TOLEDO - LUCAS COUNTY PLAN COMMISSIONS

REF: SUP25-0006

SUBJECT: Request for a Special Use Permit for a Gas Station at 1565 Alexis Road

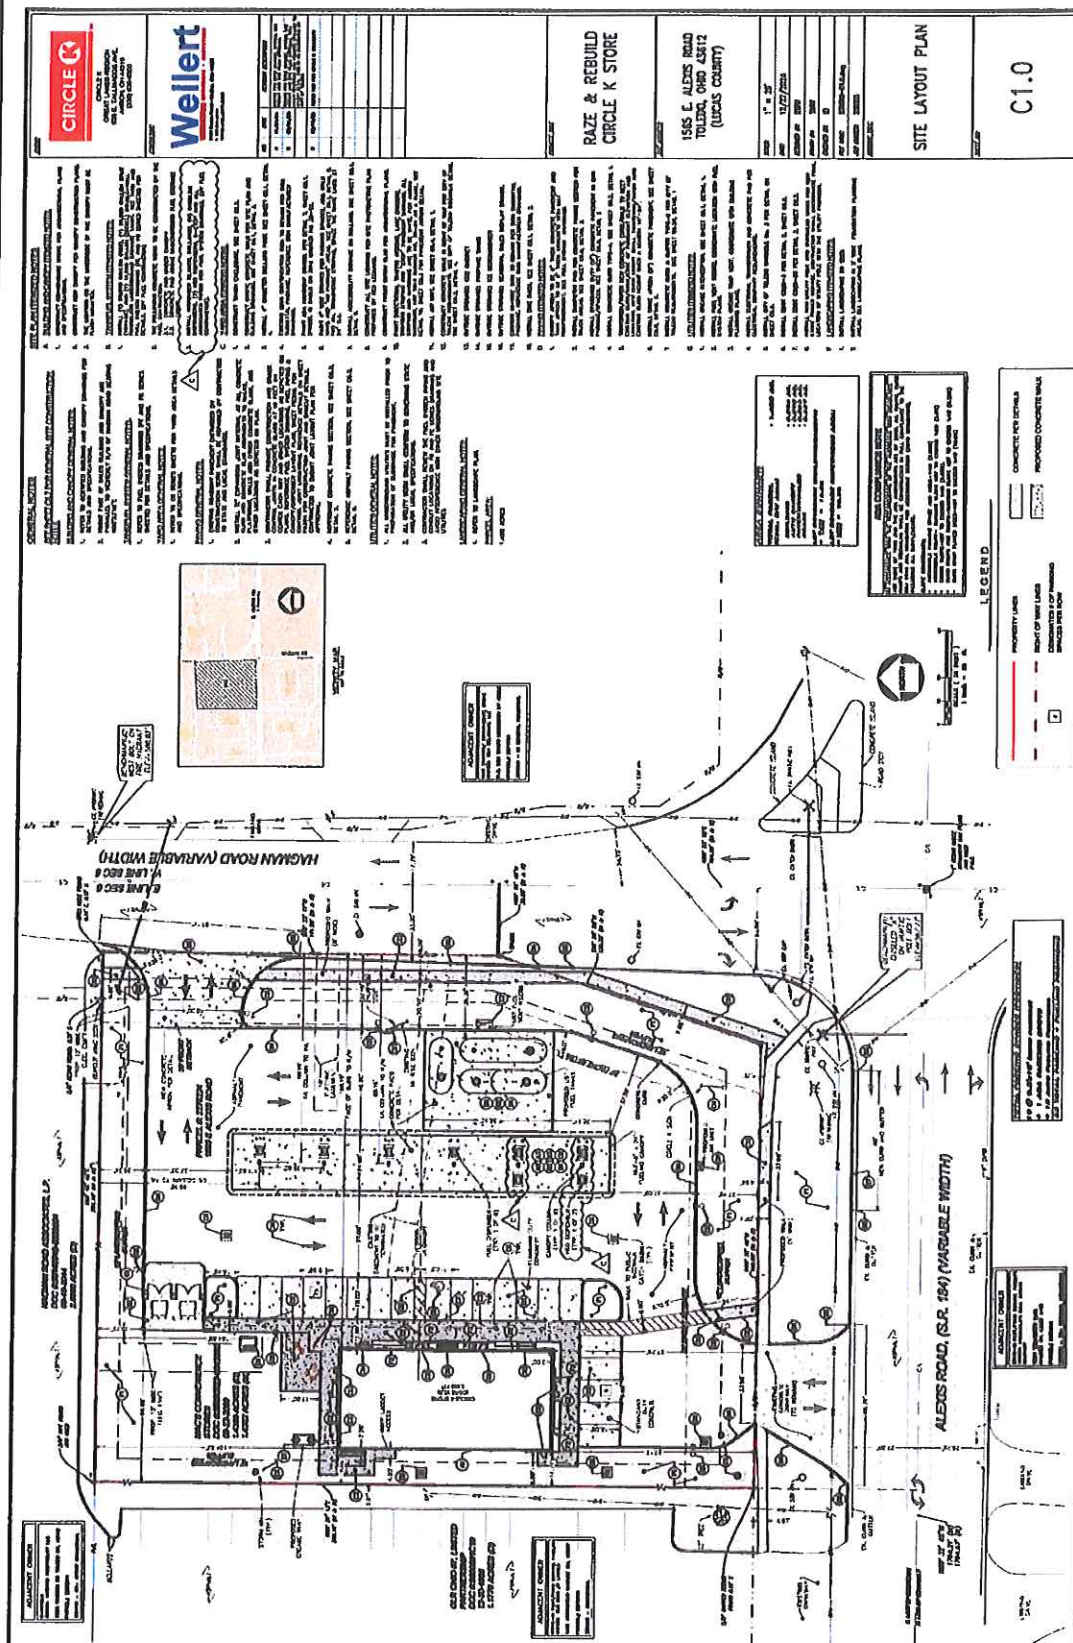
- a. The site plan meets the required minimum parking spaces (20 of 14 required), plus the 12 parking spaces at the pumps.
- b. Bicycle parking spaces are missing on the site plan. Per TMC§1107.0304, one space per 10 parking spaces shall be provided. This equates to four bicycle parking spaces. The Division of Transportation also set this condition.

- c. Per TMC §1109.0204(A) – Connecting Walkways, a pedestrian walkway from the right-of-way to the primary entrance is required. The walkway shown on the site plan goes from Alexis Road the principal building which faces Hagman Road. Given the site's configuration, an alternative cannot be determined without significant changes to the site plan.

ELEVATIONS

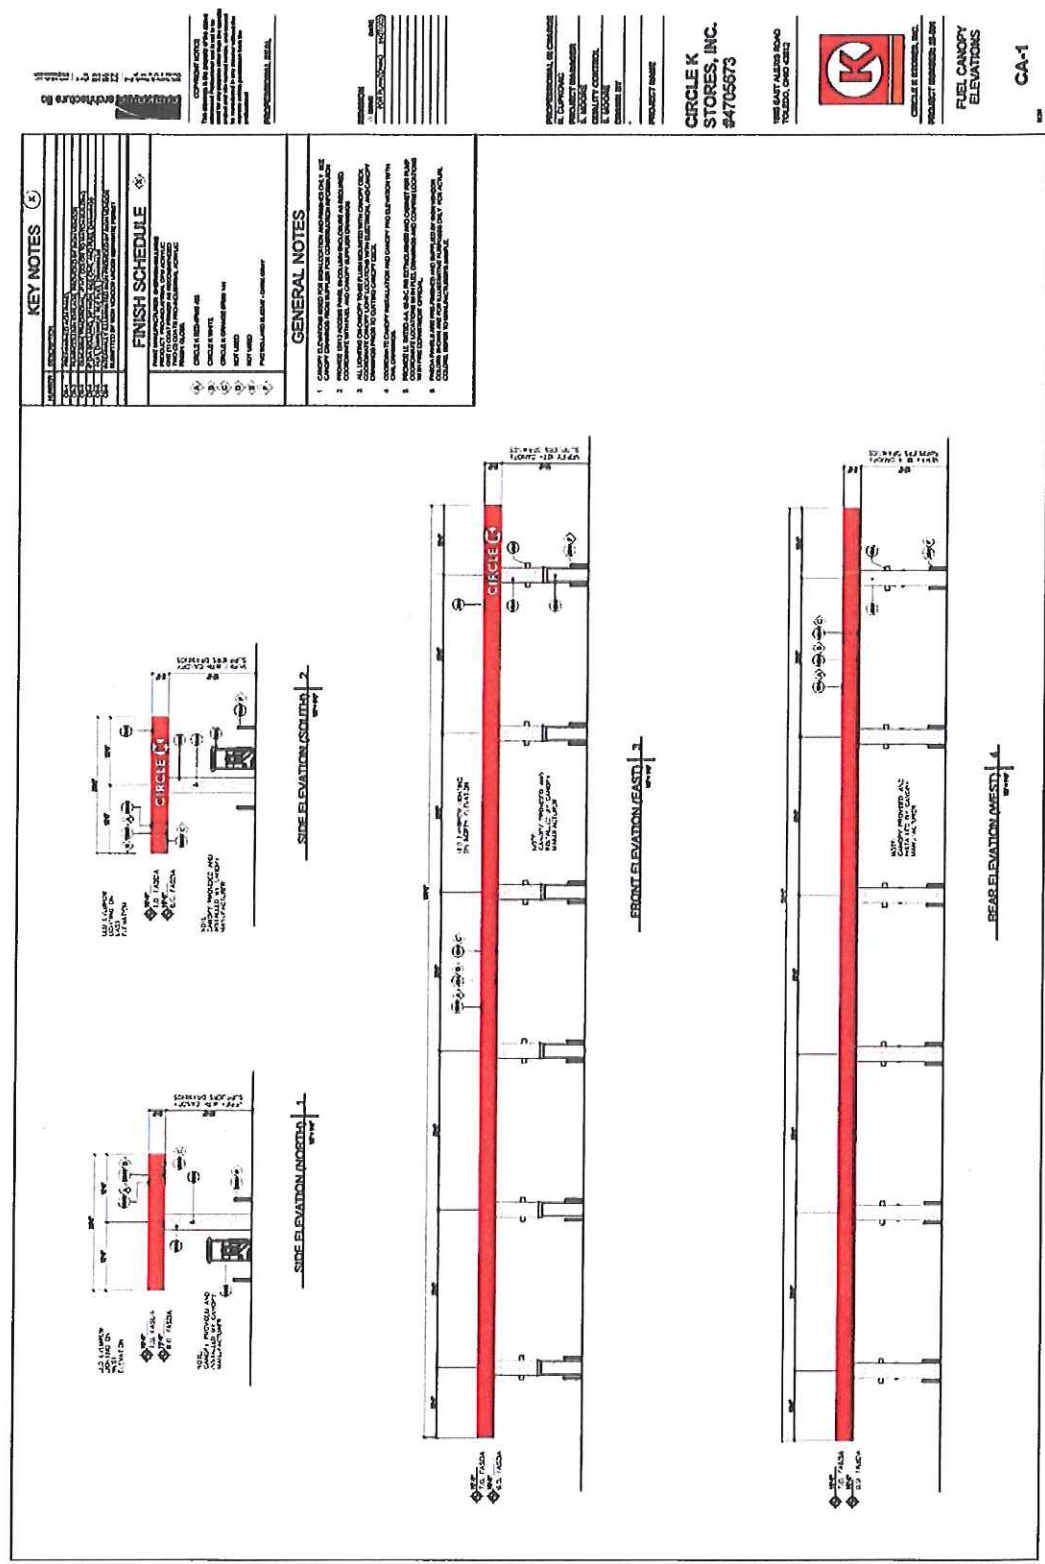
- a. The primary entrances face Hagman Road. On the East Elevation, the windows exceed the required forty percent (40%) of the elevation at grade. The South Elevation, which faces Alexis Road, does not meet the required twenty percent (20%) transparent window coverage. The window left of the doorway shown on the South Elevation is made of opaque spandrel glass.

- b. The building materials shown in the elevation are not acceptable, as the elevations depict Nichiha as the predominant façade material. This is not permitted beyond twenty (20) percent. The window coverage is not acceptable as stated above.
